Access Compliance Report

Public Rights-of-Way

(Curb Ramps)

Intersection ID: 10028595	Main Street: HONEY_CREEK_LN	Cross Street: WEDDINGTON_RD	Location:	N
ADA ID: FF6A01364AEA	Ramp Type: BlendTrans1	Initial Pass/Fail: Pass	Overall Compliance: No	Severity Score: 10

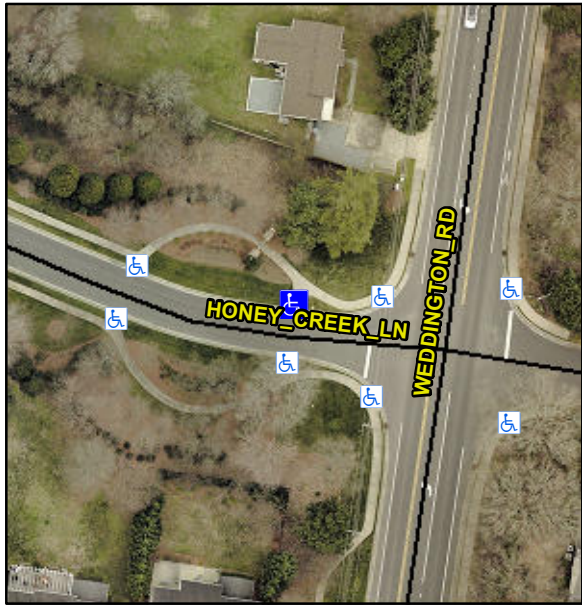
Codes/Mitigation Info/Possible Solution			Field Measurements/Component Compliance					
	Possible Solutions:		Compliance	Description	Data	Compliance	Description	Data
	Remove & Replace Curb Ramp With Two New Directional Ramps or Equivalent. Remove & Replace Gutter.		N/A	Ramp Length (in)	64.0	Yes	BlendTrans Slope (%)	5.0
			Yes	Ramp Width (in)	72.0	Yes	BlendTrans XSlope (%)	1.2
			N/A	Flare Type LT	None	N/A	Flare Type RT	None
			N/A	Flare Slope LT (%)	N/A	N/A	Flare Slope RT (%)	N/A
			N/A	Flare Traversable LT?	N/A	N/A	Flare Traversable RT?	N/A
			Yes	Landing Length (in)	54.0	No	DWS Provided?	No
			Yes	Landing Width (in)	72.0	N/A	DWS Contrast?	No
			No	Landing Slope (%)	3.7	N/A	DWS Length (in)	N/A
			Yes	Landing X Slope (%)	1.2	N/A	DWS Full Width?	No
Surveyor Notes: N/A PROW/ADA: Not Found, R304.2.2-Perp, R304.3.2-Para, R305, R304.5.3			N/A	Landing Curb? (Y/N)	No	N/A	DWS Offset (in)	N/A
			N/A	Shared Landing?	No

Yes	Gutter Ponding?	No	Yes	Gutter Slope (%)	2.6
			Yes	Gutter Lip Ht (in)	0.0	No	Gutter X Slope (%)	2.1
			N/A	Painted X Walk1?	No	N/A	Painted X Walk2?	N/A
				X Walk 1 Direction	To S		X Walk 2 Direction	N/A
				X Walk 1 Width (in)	N/A		X Walk 2 Width (in)	N/A
				X Walk 1 Slope (%)	3.7		X Walk 2 Slope (%)	N/A
				X Walk 1 X Slope (%)	0.6		X Walk 2 X Slope (%)	N/A
			N/A	Ramp inside XWalk1?	N/A	N/A	Ramp inside XWalk2?	N/A
			Road Slope (%)	0.6		Clear Space?	Yes	
			Road X Slope (%)	3.7	N/A	Clear Space to XWalk (in)	N/A	
		Yes	Any Obstructions?	No	Yes	Storm Grate/Utility Hazard?	No	
			Obstruction Type			Storm Grate/Utility Type		
					N/A			N/A
						Yes	Surface Condition? (G/P)	Good
						No	Curb Slope (%)	10.6
